PEUGEOT/CITROËN THERMOSTAT REDESIGN TO OVERCOME OVERHEATING ISSUES

Issue Date: 23/09/19 Issue Number: COTB0026F

APPLICATION : Citroën C4, DS3, Peugeot 207, 3008, 308, 5008, RCZ

APPLICABLE REFERENCES : FTK396 / FTK477

OLD DESIGN	NEW DESIGN
 <p>FTK396</p>	 <p>FTK477</p>

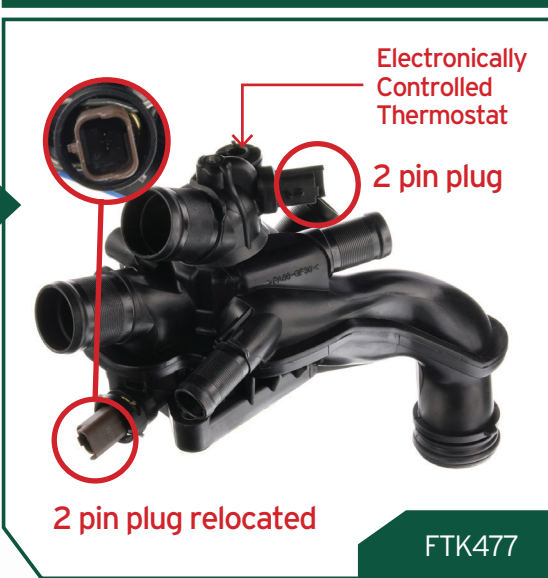
Due to an increase in overheating issues & symptoms such as an erratic temperature gauge, erratic running, radiator fan run-on, or poor heater function in the above vehicles, the O.E.M. have modified the design of the Thermostat housing. Following the O.E. specification, we have replaced the old design FTK396 with the new latest design FTK477. The latest design benefits from an electronically controlled thermostat, a reinforced structure, and a new configuration of sensors.

We have highlighted the key differences below so that you are clear that the latest part; although visually different to what may be on the vehicle, is in fact the correct product.

PLEASE NOTE:
The modified version has had the lower 2 Pin connector relocated, therefore, a new cable may also be required to carry out the modification.
New Cable: FTS3091 - Thermostat Wiring Harness

If your vehicle has the FTK396 or equivalent, then it is recommended that this is replaced with the updated version FTK477. It is advised that following replacement of these components, the software is checked and re-programmed / flashed to ensure that it is operating with the latest version.
